GEOLOGICAL SURVEY	6. IF INDIAN, ALLOTTEE OR TRIBE NAME			
SUNDRY NOTICES AND REPORTS ON WELLS	7. UNIT AGREEMENT NAME			
(Do not use this form for proposals to drill or to deepen or plug back to a different reservoir. Use Form 9-331-C for such proposals.)	8. FARM OR LEASE NAME			
	Congress

1. oil X gas other	9. WELL NO.			
2. NAME OF OPERATOR	18			
Union Texas Petroleum Corporation	10. FIELD OR WILDCAT NAME			
3. ADDRESS OF OPERATOR	Undesignated Gallup

16. CHECK APPROPRIATE BOX TO INDICATE NATURE OF NOTICE				
REPORT, OR OTHER DATA	ELEVATIONS (SHOW DF, KDB, AND WD)			
REQUEST FOR APPROVAL TO: SUBSEQUENT FETTER OF:	.5517 GÅ			
5	1903			
FRACTURE TREAT	SURVEY JOEREN CO			
SHOOT OR ACIDIZE	CICAL SURVEY DE CE I WE FORWARD CHANGE OF FORM 9-330.)			
REPAIR WELL	CONNOTE: Report results of multiple completion or 20ne change on Form 9-330.)			
— — — — — — — — — — — — — — — — — — —	MAY 18 1983			
MULTIPLE COMPLETE	201000			
ABANDON* □	Oil COM Day			
(other) Revise cut and fill and rig layout for the	is proposed well.

LOCATION CUT AND FILL PLAT

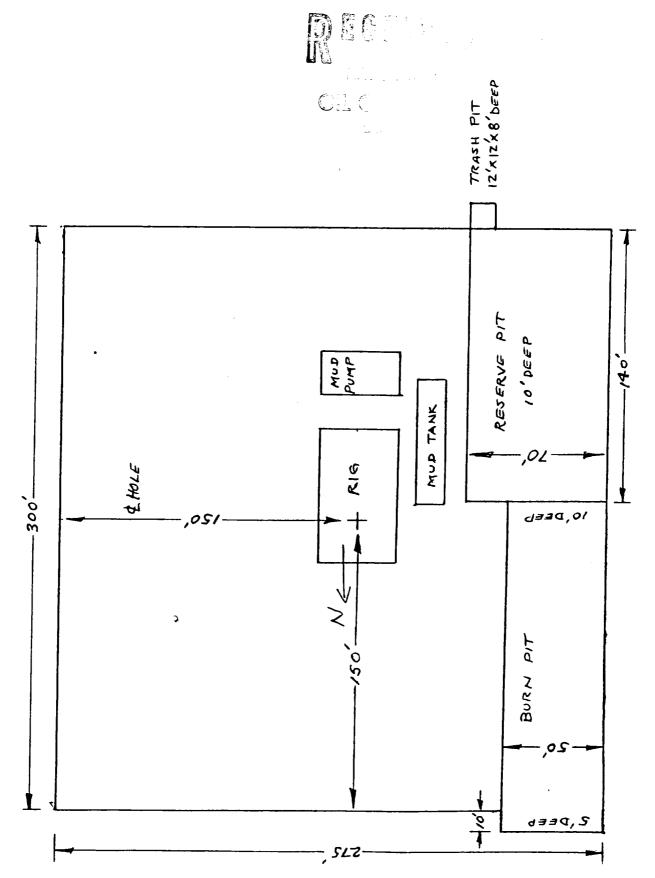
17. DESCRIBE PROPOSED OR COMPLETED OPERATIONS (Clearly state all pertinent details, and give pertinent dates, including estimated date of starting any proposed work. If well is directionally drilled, give subsurface locations and measured and true vertical depths for all markers and zones pertinent to this work.)*  We desire to change the orientation of the rig by rotating it approximately 180° on the approved site. This is necessary because of the proximity of the Hammond Ditch and the possibility of getting spray or splash in the irrigation water.				
Subsurface Safety Valve: Manu. and Type	Set @ Ft.
